# HISTORIC AND DESIGN REVIEW COMMISSION

**HDRC CASE NO:** 2022-239  
**ADDRESS:** 702 HAYS ST  
**LEGAL DESCRIPTION:** NCB 540 BLK 11 LOT A16  
**ZONING:** R-5, H  
**CITY COUNCIL DIST.:** 2  
**DISTRICT:** Dignowity Hill Historic District  
**APPLICANT:** Kuba Zarobkiewicz/ZAROBKIEWICZ KUBA  
**OWNER:** Kuba Zarobkiewicz/ZAROBKIEWICZ KUBA  
**TYPE OF WORK:** Construction of a rear addition, exterior modifications, window replacement, rehabilitation, roofing material change  
**APPLICATION RECEIVED:** May 06, 2022  
**60-DAY REVIEW:** Not applicable due to City Council Emergency Orders  
**CASE MANAGER:** Edward Hall

**Historic and Design Review Commission**  
***Design Review Committee Report***

NEW RESIDENCE ADDITION & STUDIO UNIT FOR  
KUBA & KIMBERLY ZAROBKIEWICZ  
702 HAYS ST.  
SAN ANTONIO, TEXAS 78202

**4 LEFT ELEVATION**  
 SCALE: 1/4" = 1'-0"

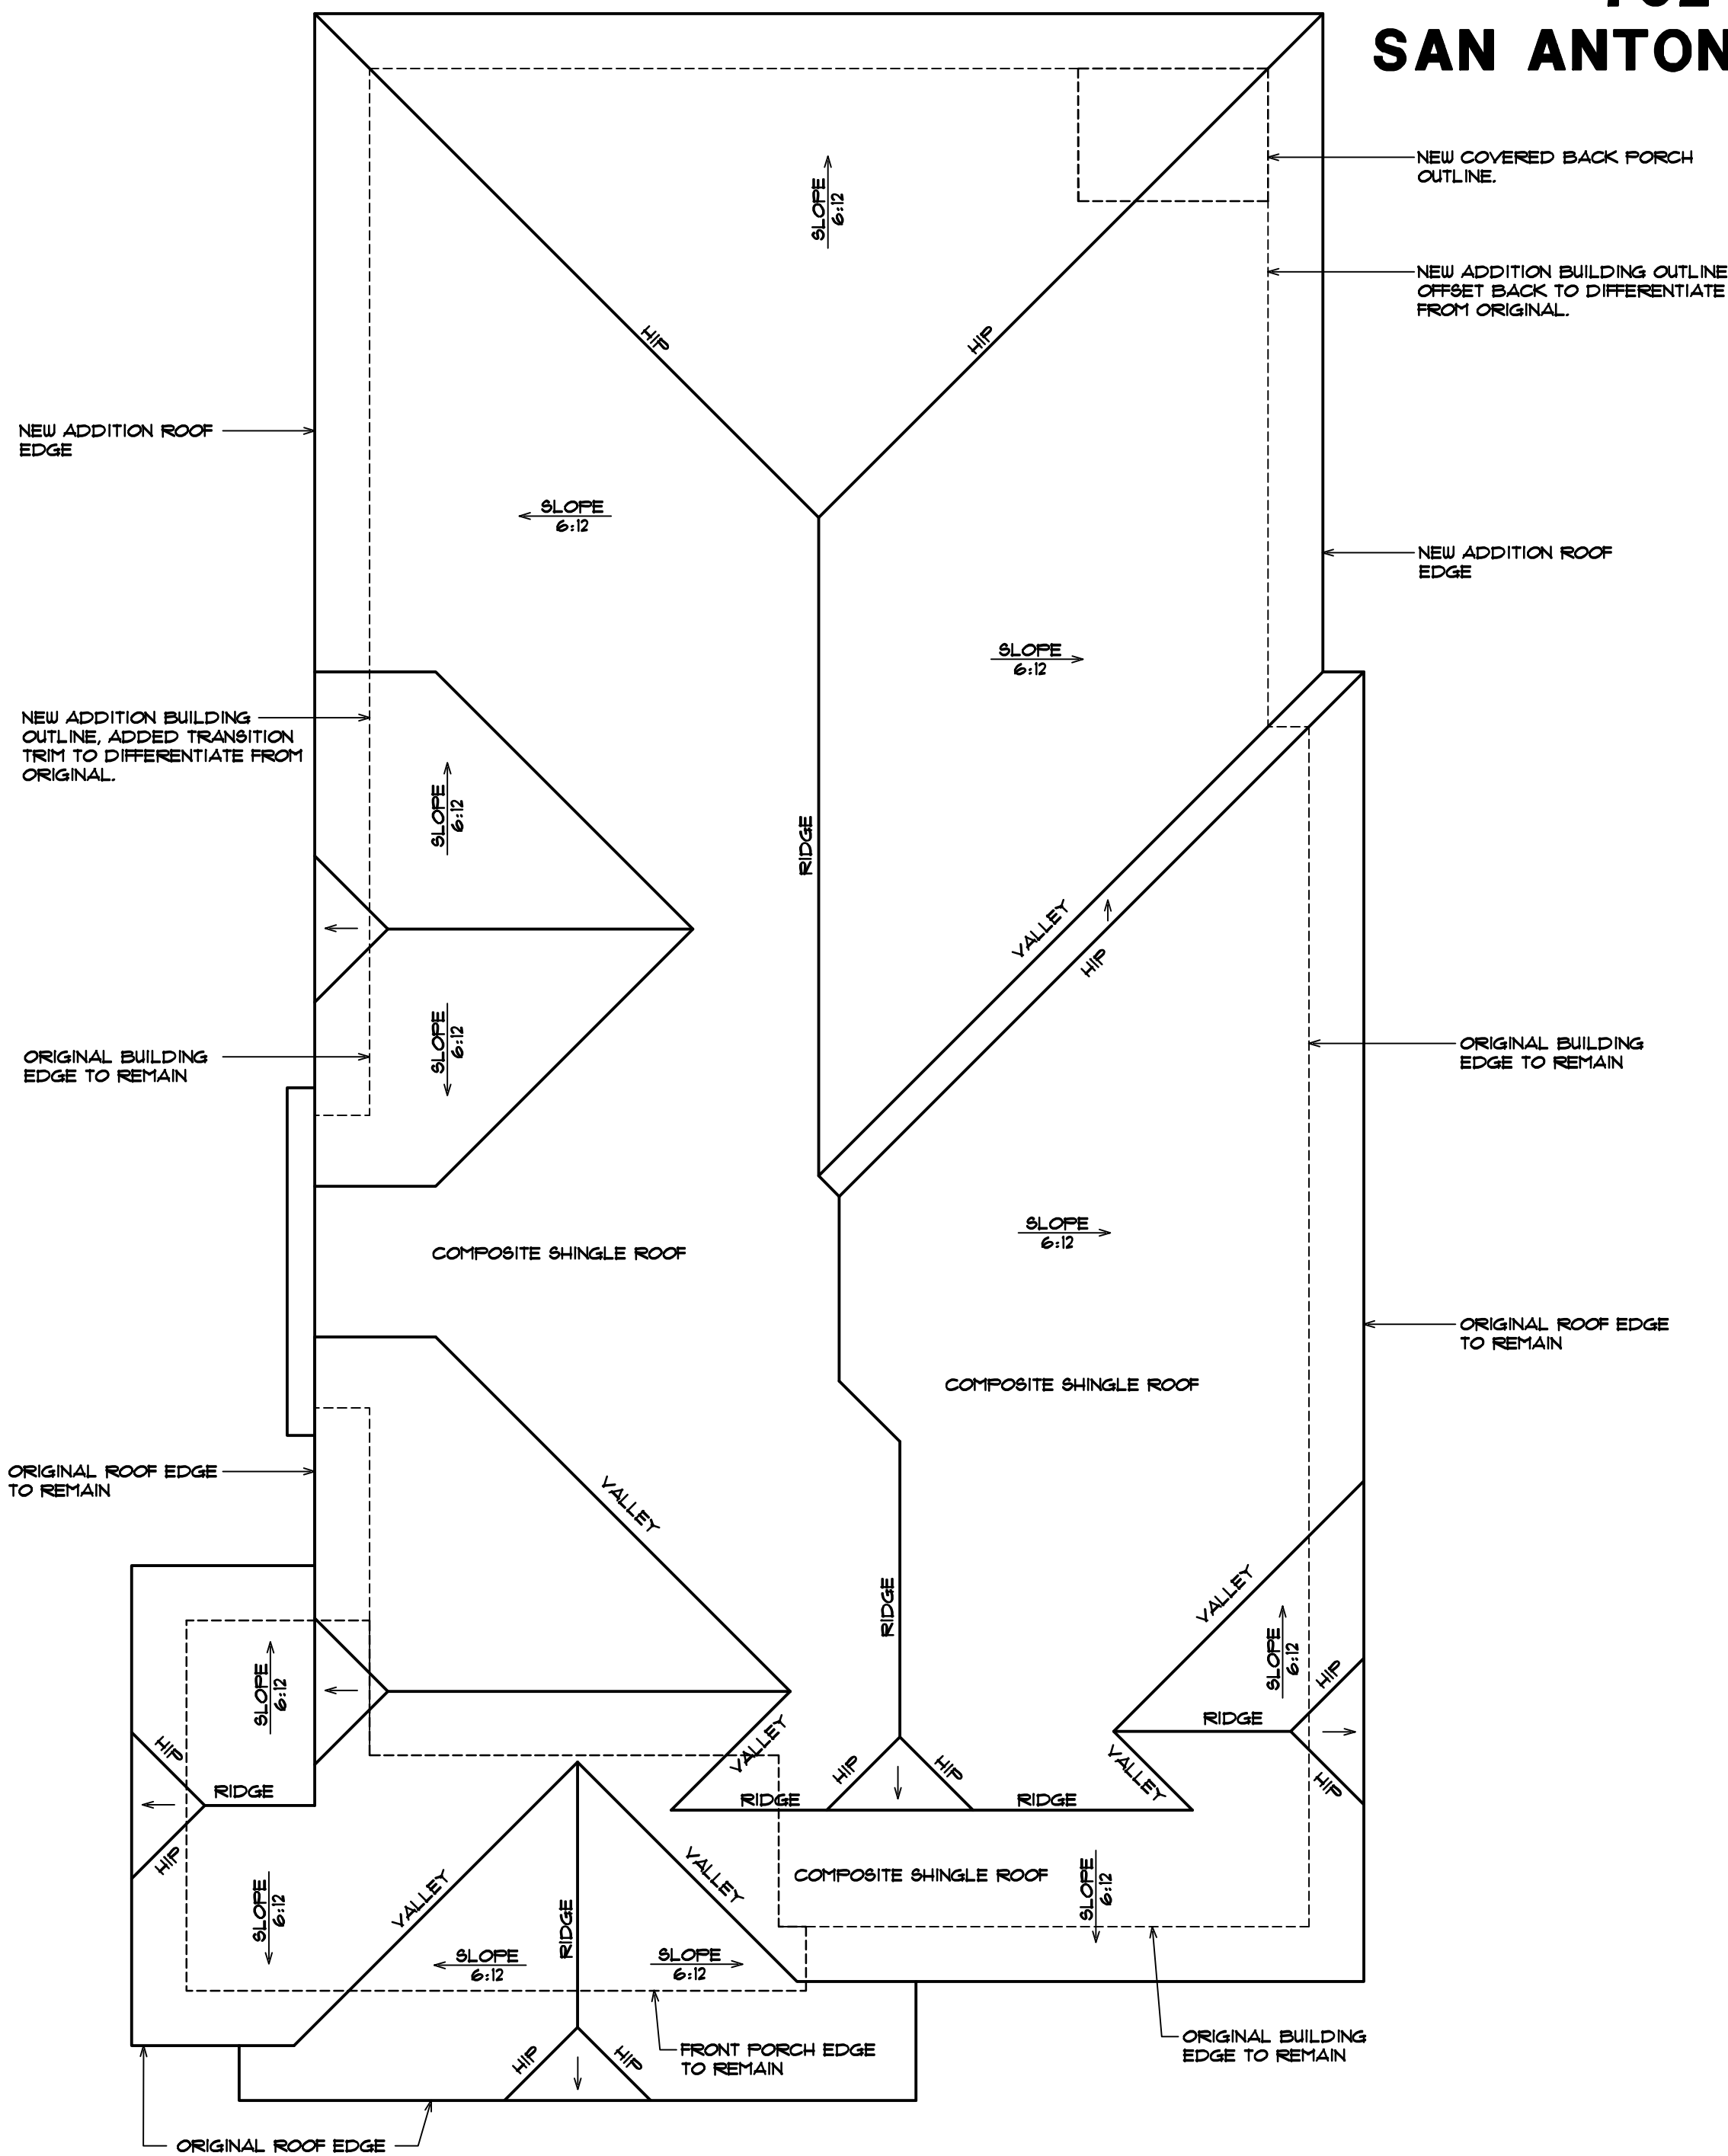
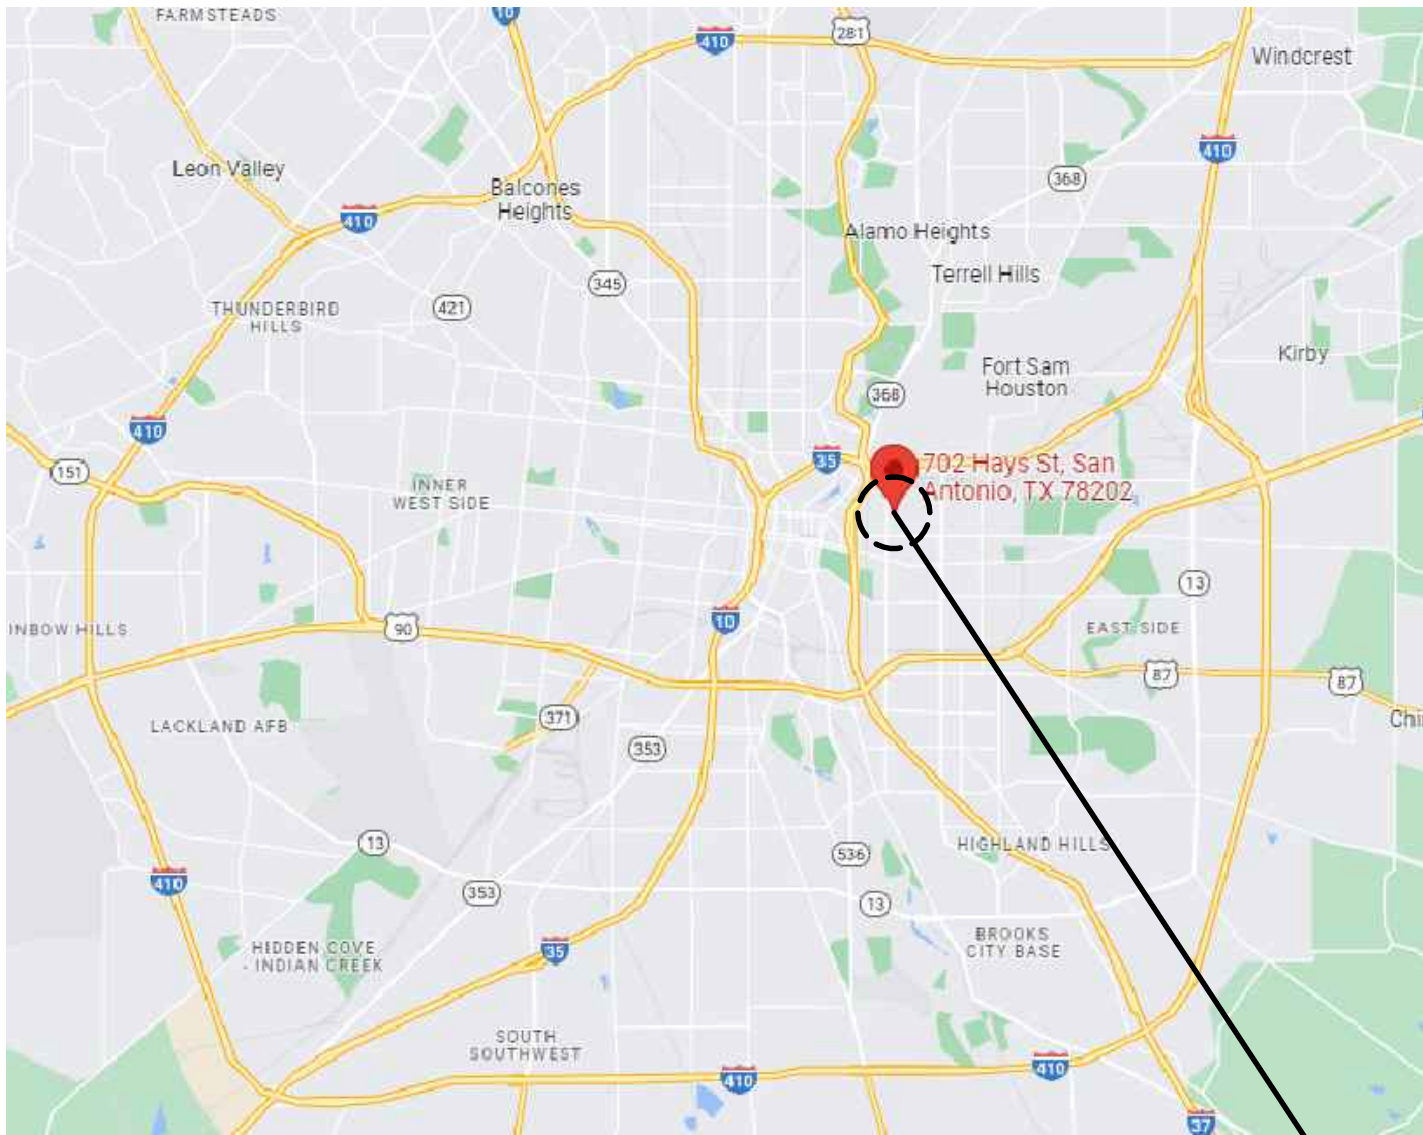
REVISIONS SUBMITTED TO ADDRESS COMMENTS FROM OHP STAFF AND THE DRC - THESE REVISIONS ARE NOT REFLECTED IN STAFF'S FINDINGS OR RECOMMENDATIONS.
